**BEFORE THE
PUBLIC SERVICE COMMISSION OF WISCONSIN**

Joint Application of Dairyland Power Cooperative,
Northern States Power Company-Wisconsin, and Wisconsin
Public Power, Inc., for Authority to Construct and Place
In Service 345 kV Electric Transmission Lines and
Electric Substation Facilities for the CapX Twin Cities-
Rochester-La Crosse Project, Located in Buffalo, Trempealeau,
And La Crosse Counties, Wisconsin

Docket No. 05-CE-136

INITIAL BRIEF OF THE CITIZENS UTILITY BOARD

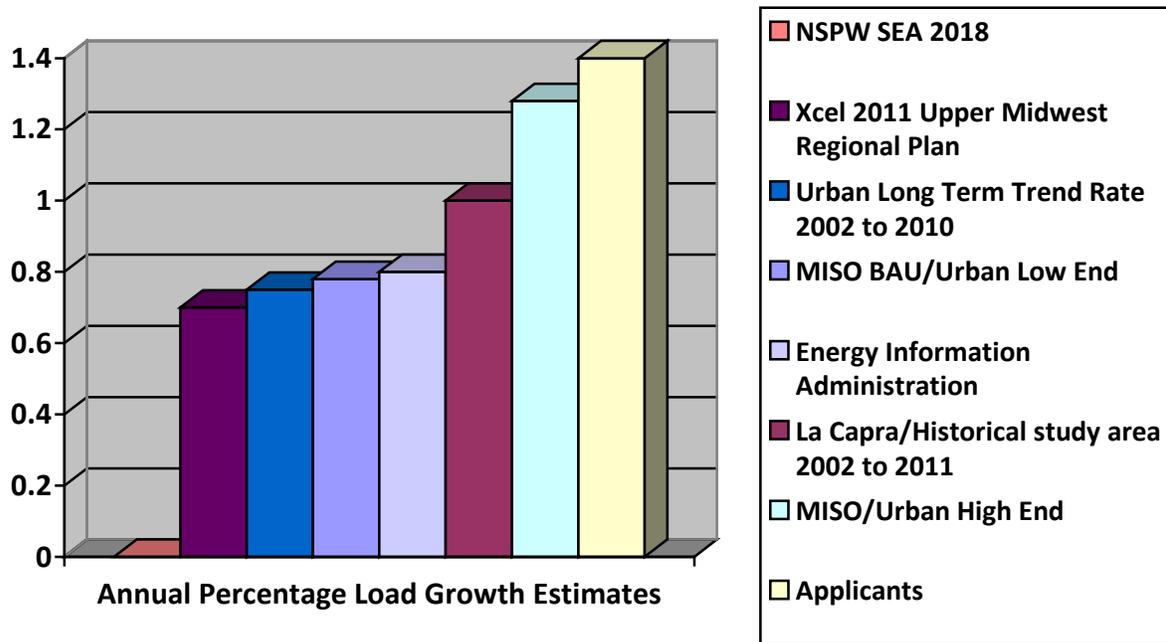
CUB witness Mr. Hahn analyzed the Applicants historic actual coincident peak load growth (from 2002 to 2011) and the benchmark forecasts identified for the region and determined that a reasonable annual percentage load growth rate for the study area over the study period is 1.0 percent. (Direct-CUB-Hahn-13) Dr. Urban estimated a reasonable load growth range for the study area to be between 0.78 percent and 1.28 percent. (Urban, Tr. 647) As shown in the chart below, Mr. Hahn's load growth estimate compares favorably to the

benchmarks for the region and Dr. Urban’s estimates, while the Applicants’ load forecast is significantly higher than historical growth and the regional benchmarks. (Direct-CUB-Hahn-13)

Dr. Urban testified that Mr. Hahn’s 1.0 percent load growth estimate was more reasonable than the Applicants and was more in line with her estimation. (Rebuttal-PSC-Urban-

4) The Commission should likewise conclude that a reasonable load growth estimate for the study area over the study period is 1.0 percent.

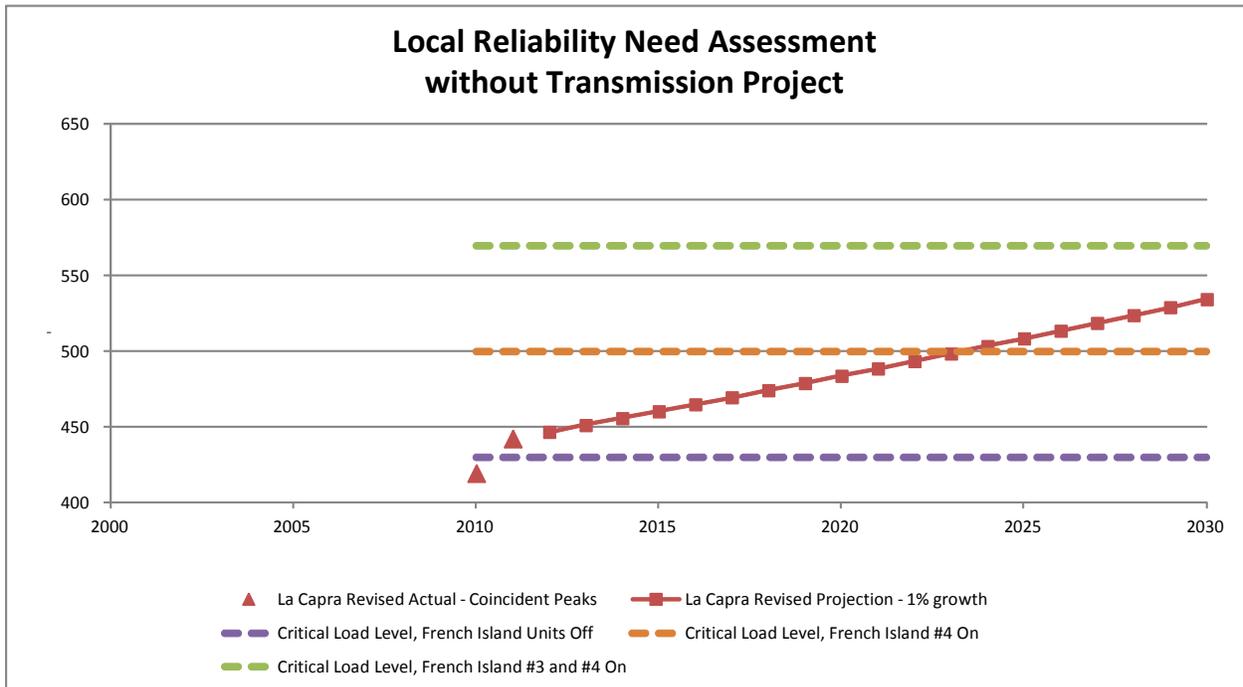
However, the Applicants' critical load level analysis is overly cautious because it did not take into account French Island Units 3 and 4. (Direct-CUB-Hahn-16) French Island Units 3 and 4 are two 70 MW oil-fired peaking units in the study area that are owned and operated by NSPW. (Direct-CUB-Hahn-15) French Island Unit 3 has been mothballed, but French Island Unit 4 is currently operational. (Ex.-PSC-Rineer-1, Part 4 of 78, p. 17) The Applicants performed their critical load level analysis with both French Island units "turned off" in the power flow model. (Direct-CUB-Hahn-15) As Mr. Hahn explained, all actually available system elements in the study area should be assumed to be available in the power flow model analyzing the critical load level except those elements identified to meet the N-2 criteria. (Direct-CUB-Hahn-16 to 17) Depriving the power flow model of additional system elements beyond the outages assumed for the N-2 criteria is akin to planning for an N-3 contingency, which is above and beyond NERC requirements. (*Id.*) If French Island Unit 4 is assumed to be

available on the system during the N-2 system contingency, the critical load level for the study area increases from 430 MW to 500 MW. If French Island Unit 3 is reactivated from mothball status and assumed to be available during the N-2 system contingency,⁴ the critical load level increases to 570 MW. (Direct-CUB-Hahn-17) Thus, as Mr. Hahn explained, there is a range of reasonable critical load levels for the study area (i.e., between 430 MW and 570 MW) depending on the assumed availability of the French Island Units (Direct-CUB-Hahn-17).
